City of Somerville

# PLANNING, PRESERVATION, & ZONING

May 5, 2026

Your application for a Plan Revision to your approved plans at 720 Broadway (ZP24-000047- Special Permit, ZP24-000048 – Site Plan Approval), case number ZP25-000117, has been deemed *de minimis* and accepted. Please see notes below and attached exhibits.

A-04

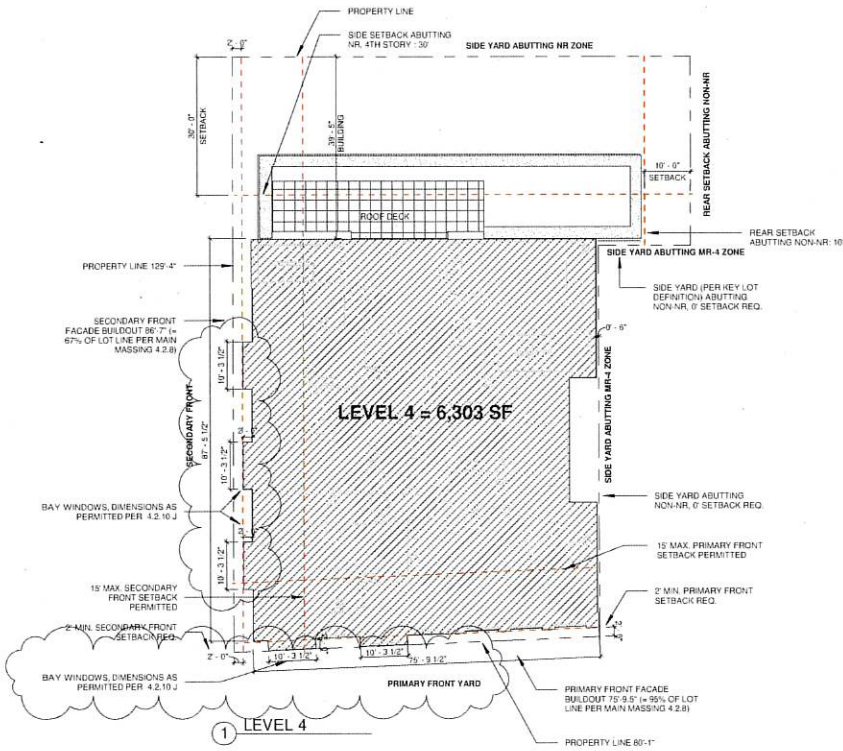
- A-03: Dimensional Compliance
  - Chart figure updated: Long Term Bike storage: 27
- A-04: Dimensional Compliance Diagram
  - Compliant distance between entrances on Broadway updated to reflect proposed commercial door locations. Compliant commercial space depths updated for three proposed commercial spaces (along Broadway and Willow).

- Compliant commercial space depths updated for two proposed commercial spaces (along Broadway and Willow). Note: one of the proposed commercial spaces has been removed in order to satisfy the required min. depth of 30'. There are now two proposed commercial spaces.

A-04: Dimensional Compliance Diagram

Compliant commercial space depths updated for two proposed commercial spaces (along Broadway and Willow). Note: one of the proposed commercial spaces has been removed in order to satisfy the required min. depth of 30'. There are now two proposed commercial spaces

A-05

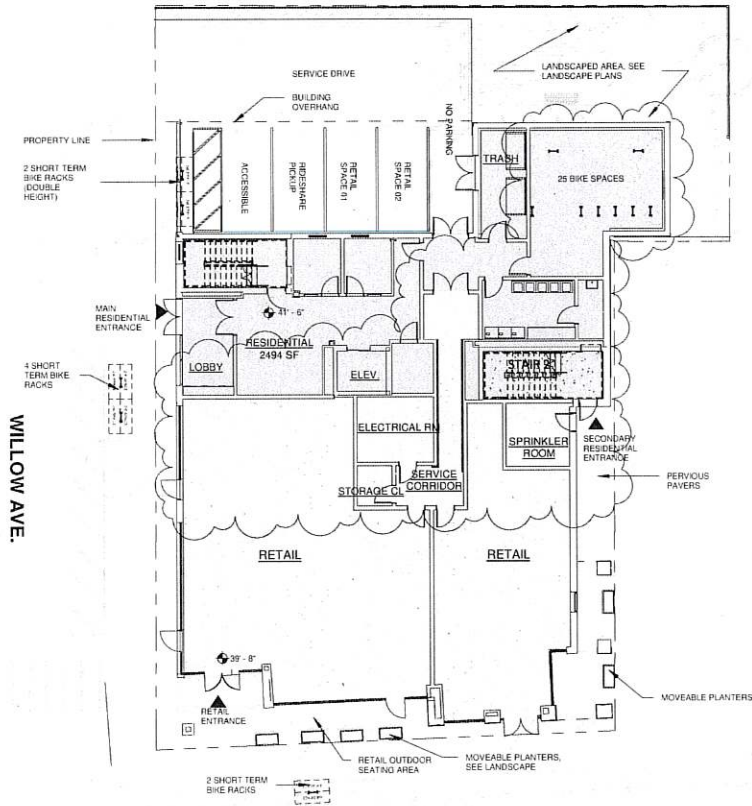
- A-05: Dimensional Compliance Diagram
  - Bay windows on the 4th floor are dimensioned for compliance with 4.2.10 J

A-05: Dimensional Compliance Diagram

Bay windows on the 4<sup>th</sup> floor are dimensioned for compliance with 4.2.10 J

A-19

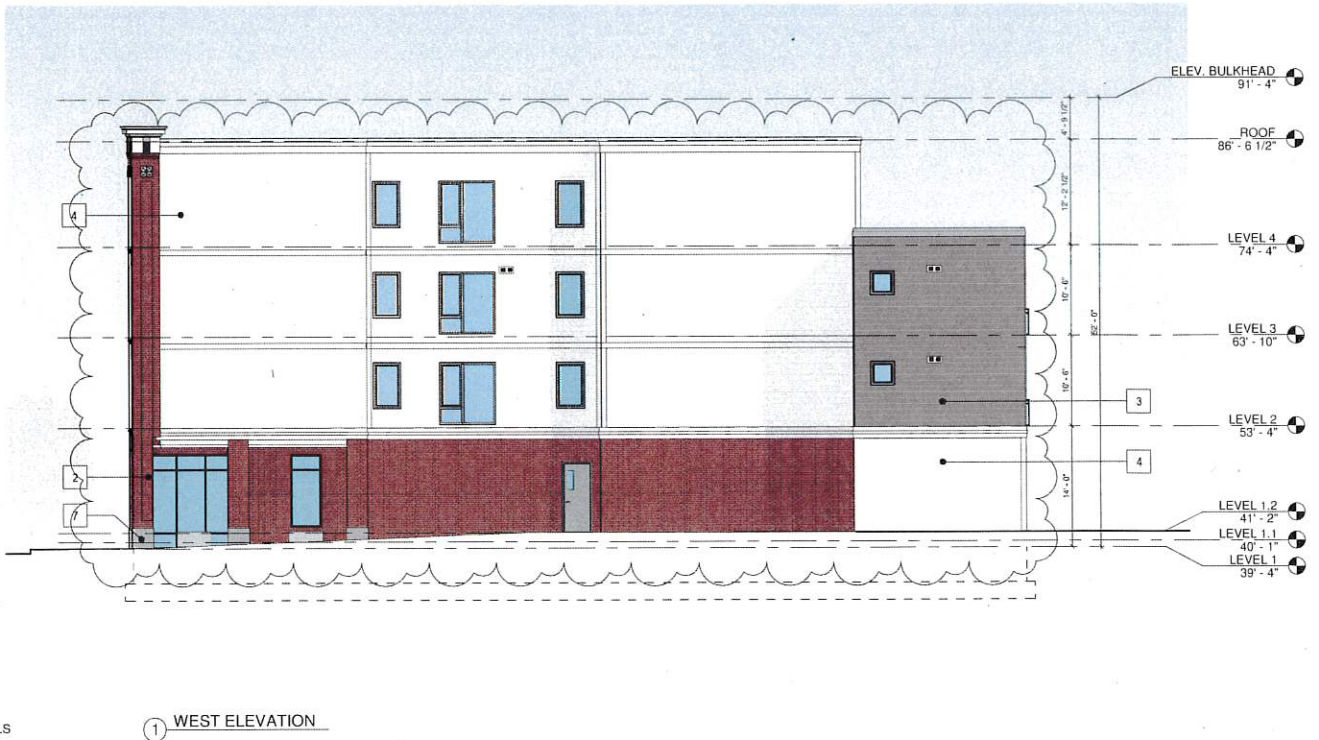
- A-18: Building Elevation
  - Revised fenestration
- A-19: Building Elevation
  - Revised fenestration
- A-28: Fenestration Diagrams
  - Revised fenestration calculations

A-19: Building Elevation

Revised fenestration
